Near-Infrared Tip-Tilt Sensor Preliminary Design Review

KAON 863
April 25, 2011

Response to SDR Review Committee Report

MASS BREAKDOWN

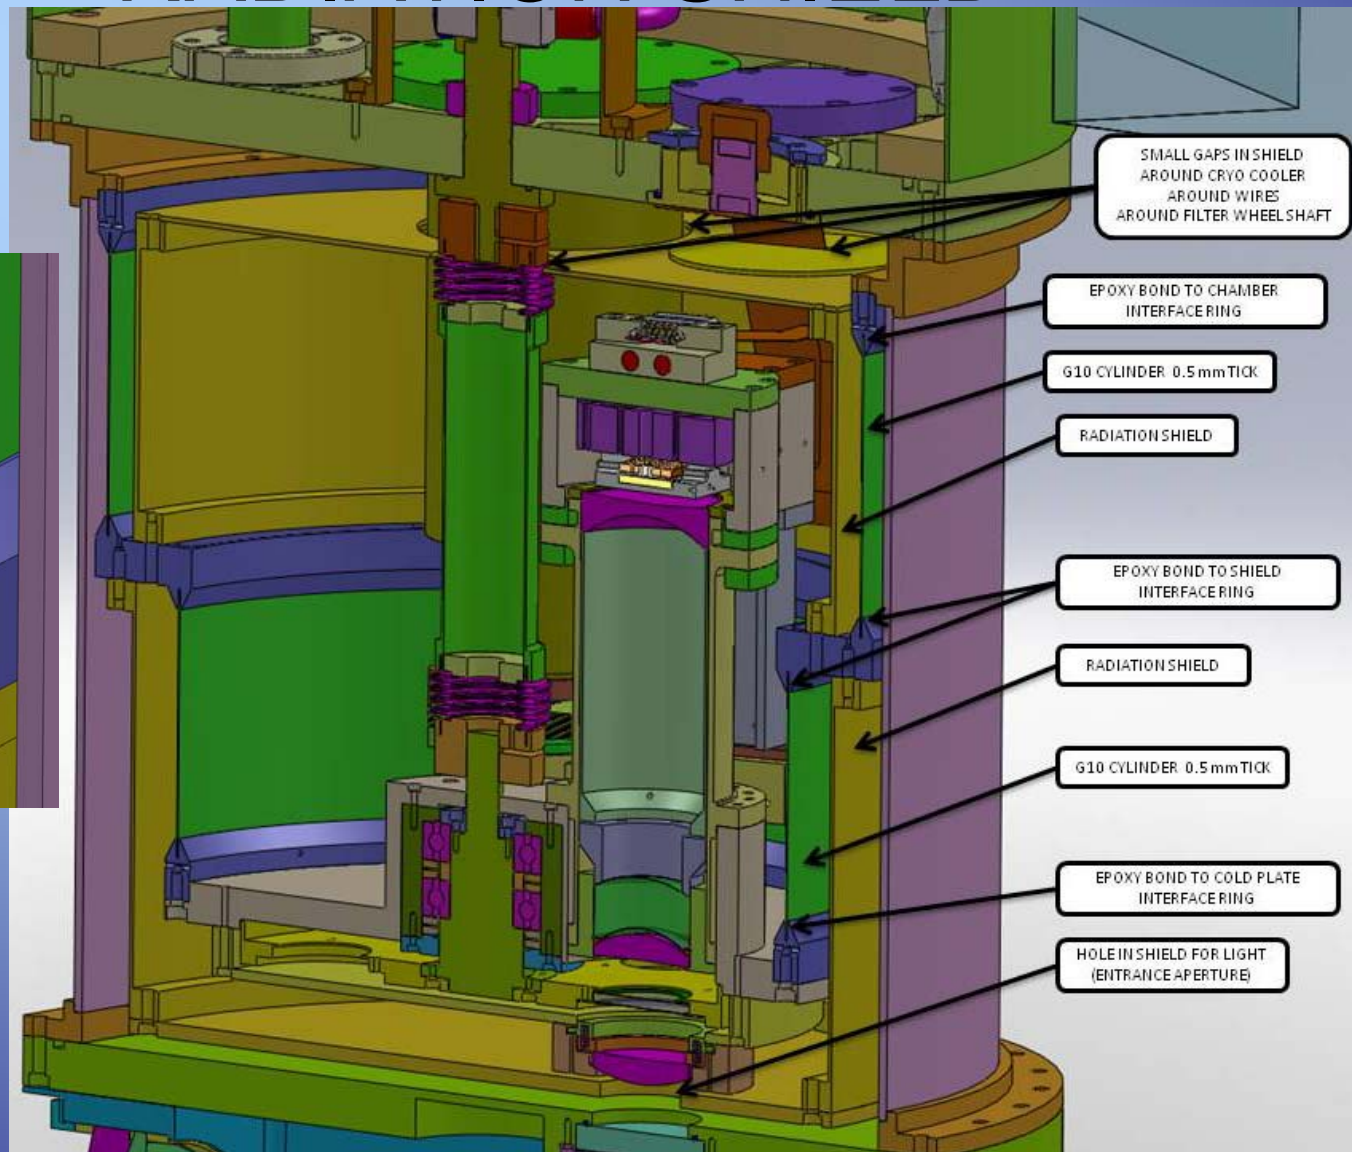
RIQ-CBO3: Is there a plan to do a flexure analysis of the TRICK system during DD and also to check the impacts on AO bench?

Much heavier than originally estimated:

- Cryostat and base, no light weighting = 103 lb
- With light weighting = 85 lb
- Analysis in DD phase is planned to determine if cost of light weighting is justified, etc.

Filter Pupil Mounting

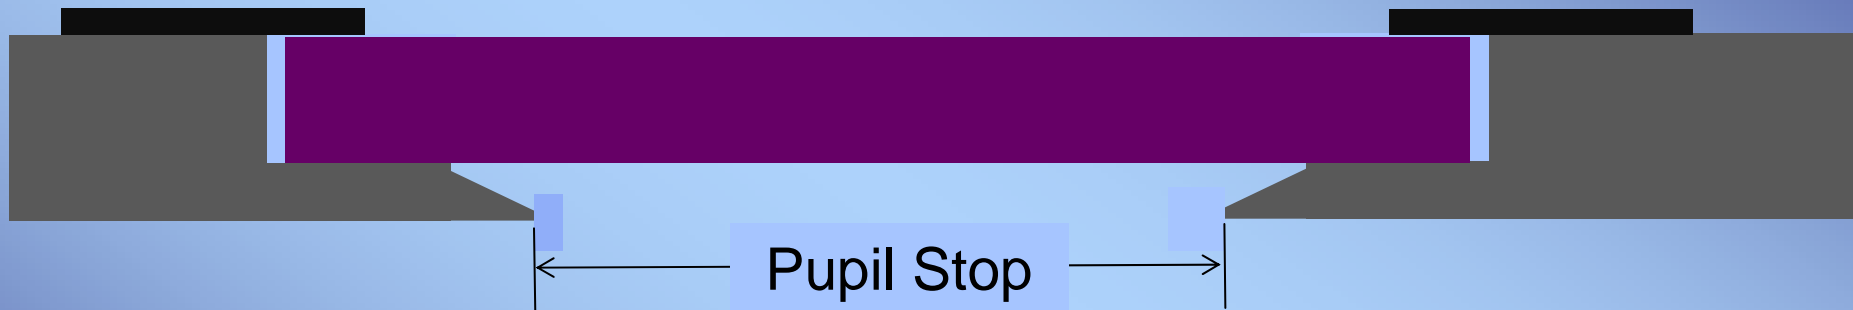
RIQ-RDC6: It's not clear to me how the filters/pupil stops will be mounted? What material will be used. Is there any mechanical design work done yet for the filter holders/pupil masks. I'm concerned about restraining the filters without possible coating damage to the filters.

- Contact made outside optical path.
- Precise pupil stop machined into filter wheel itself, for best repeatability and minimal radial position variation from filter to filter.
- Tangential position errors will be corrected with drive system.

THERMAL LOAD & COOLING TIME

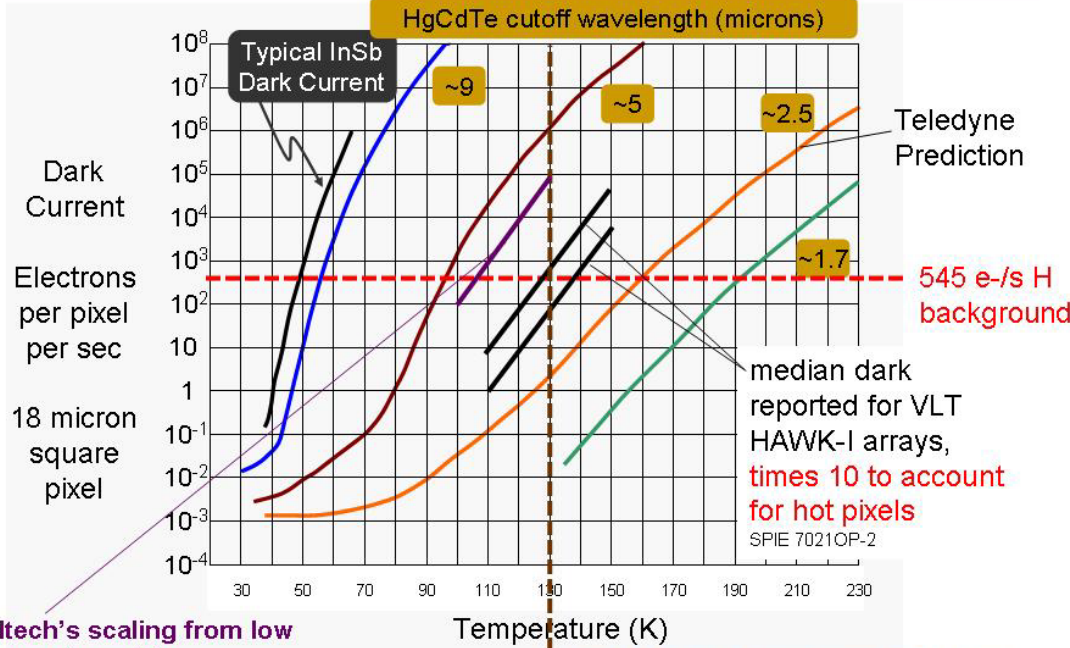
RIQ-BCO3: Have you performed a cool-down analysis and estimated the time for cool-down and warm-up?

- Equilibrium thermal load on cryocooler < 4 W
 - 0.45 m² radiation shield : < 2 W
 - 0.0009 m² gaps have unit emissivity: 0.02 W
 - Radiation through entrance window: 0.4 W
 - Conduction through G10 Shield support: <0.25 W
 - Conduction through G10 drive shaft: 0.05 W (allocation)
 - Conduction through electrical wires: 0.15 W (allocation)
 - Heater power allowance: 1 W
- Cryotiger with high performance head and PT14 gas: 15 W peak
- Cooling time currently ~36 hr, will be reduced to < 24hr
 - by light-weighting cooled mass from 6.5kg to ~4kg.
 - In DD phase will adapt existing numerical models to provide better estimate: may permit cost saving on low emissivity coatings.
- Warming time = 4 hr: active heating enforces 1K/min slew rate.
 - ~80 W heater power from 2nd servo loop on Lakeshore controller

4) Software

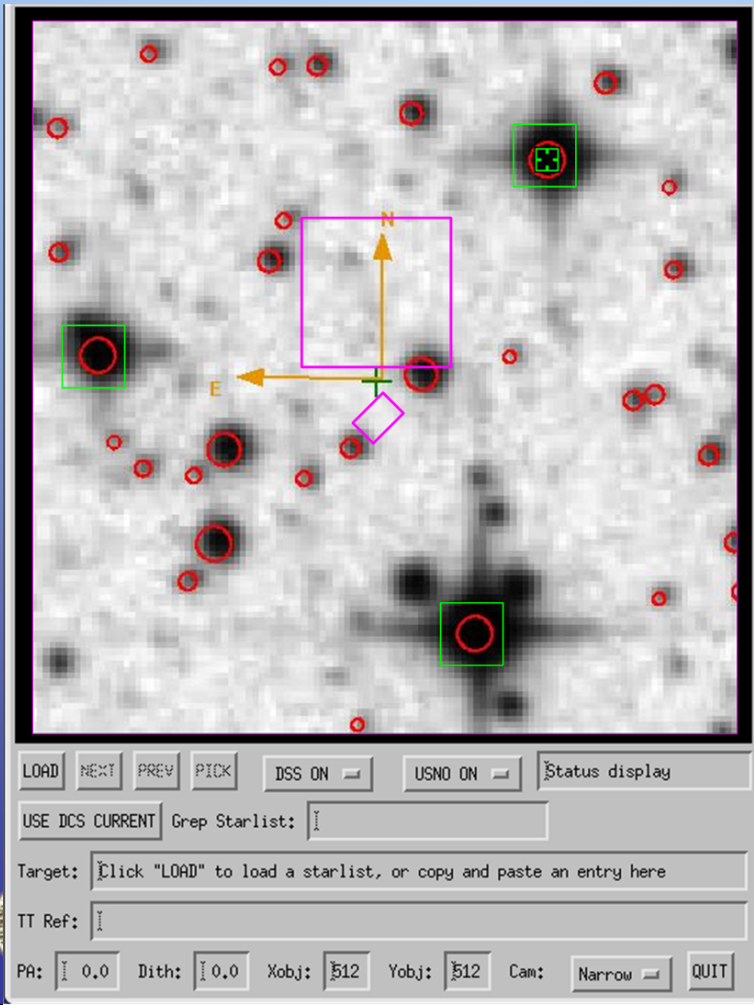
- Why not use existing tools such as MAGIQ for adjusting the guide star selection during observations and for centering the science object?

- Sorry for confusion on this topic
 - due to incomplete updates of the O OCD & PDM
- MAGIQ/ACAM will primarily be used for acquisition
- NIR TTS camera only used as a backup if IR field ID required
- Neyman, Lyke, Kwok & LaVen concluded this was a workable solution considering:
 - Still need a visible star for LBWFS
 - Use visible star to adjust telescope pointing with ACAM/MAGIQ
 - Catalog position good enough to assign initial ROIs (16x16, 8x8)
 - Determine if the NIR star is usable (not a double, galaxy, etc.) by closing tip-tilt loop & monitoring performance with the NIR Status tool
 - NIR TTS full frame image display provides IR field ID if required
